## PLANNING COMMITTEE – Thursday 18 June 2026

**26/0325/RSP – Part Retrospective: Erection of raised terrace area including associated steps, landscaping and plant room following alterations to existing rear patio, plant room and hard surfacing at Sandalwood, 7a Wolsey Road, Moor Park, Northwood, HA6 2HN.**

Recommendation: That Part Retrospective Planning Permission be approved subject to conditions.

2 - 22/1309/RSP Proposed Site Plan - Refused

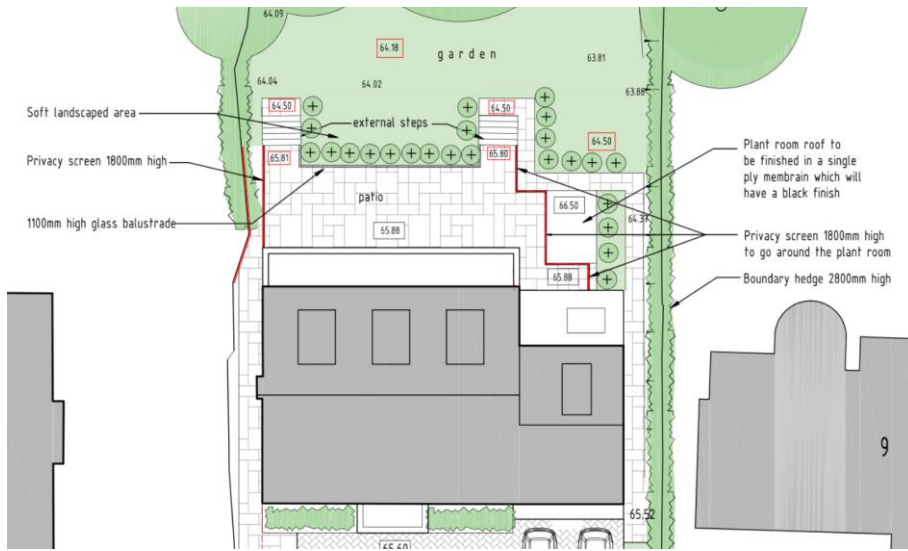
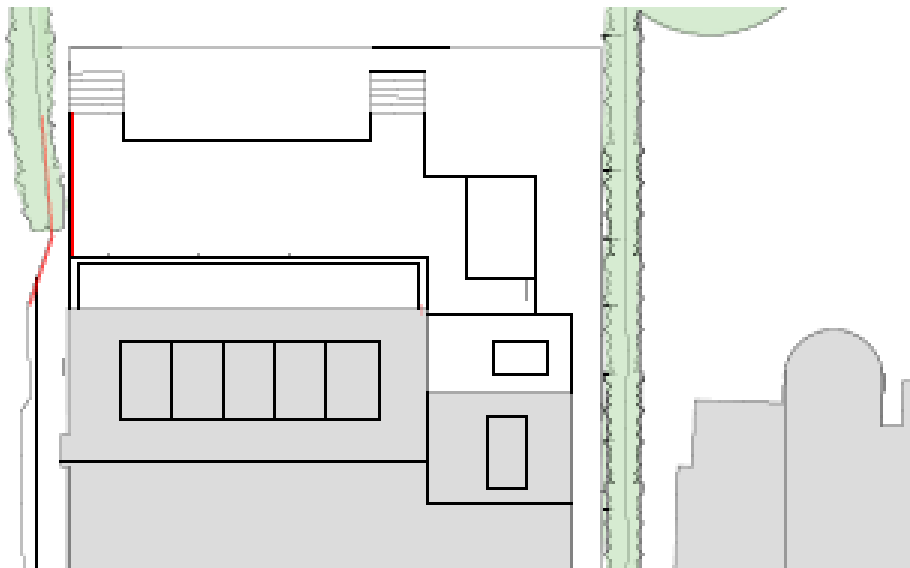
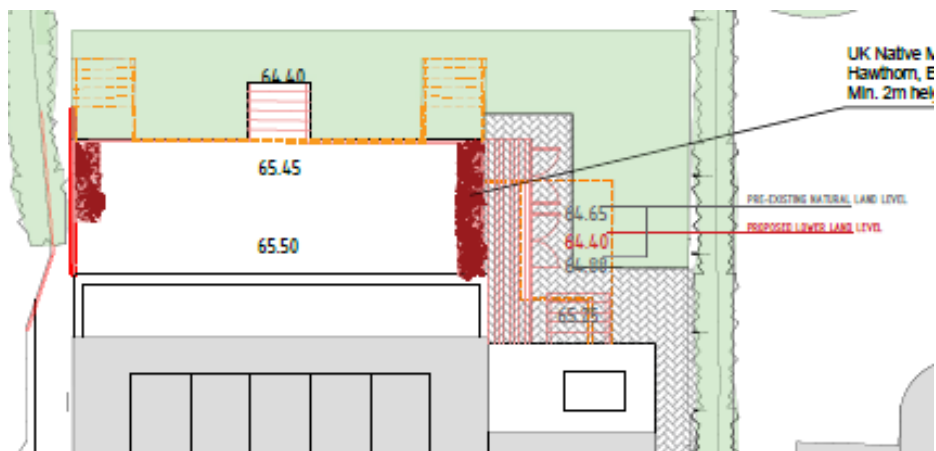
8.1.8 **The extracts from plans and photographs below** illustrate the differences between the proposed development, previously approved development, and the unauthorised development in situ:

5 - Raised Patio Near to Floor Level [Proposed Rear Elevation] 21/2425 (20/2292/FUL)

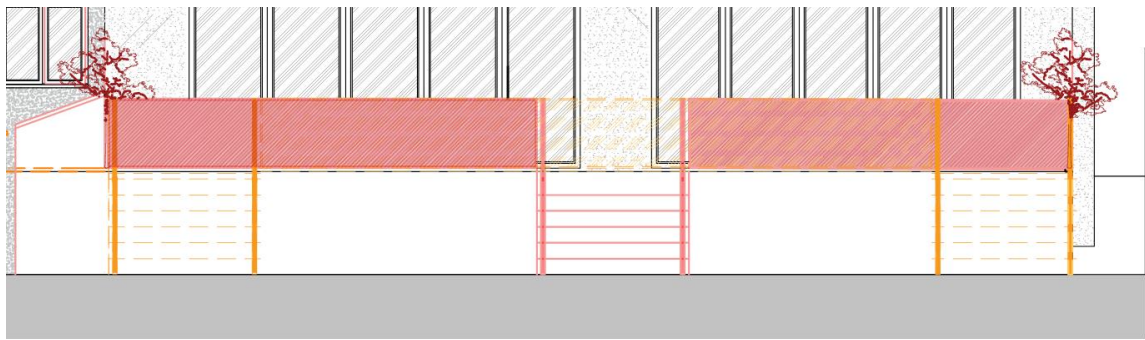
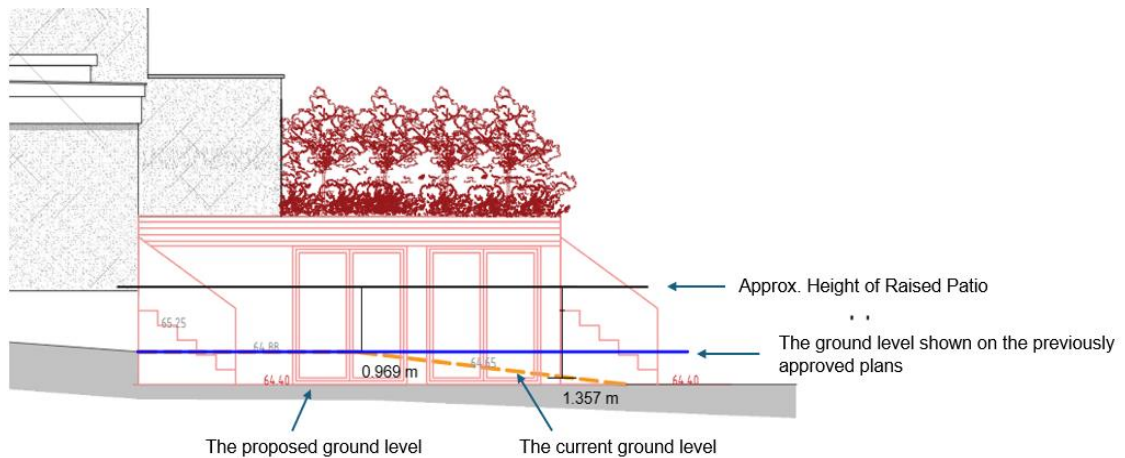
8.1.10 Furthermore, with regards to the height of the raised patio, it is also considered that the principal of a raised patio level with the floor level of the rear extension has also been established, as indicated on the plans below:

8.1.11 The discrepancies between the previously approved height and the proposed height (and height in situ) appears to be related to the adjacent land levels, as can be seen on the comparison between the previously approved and proposed plans below:
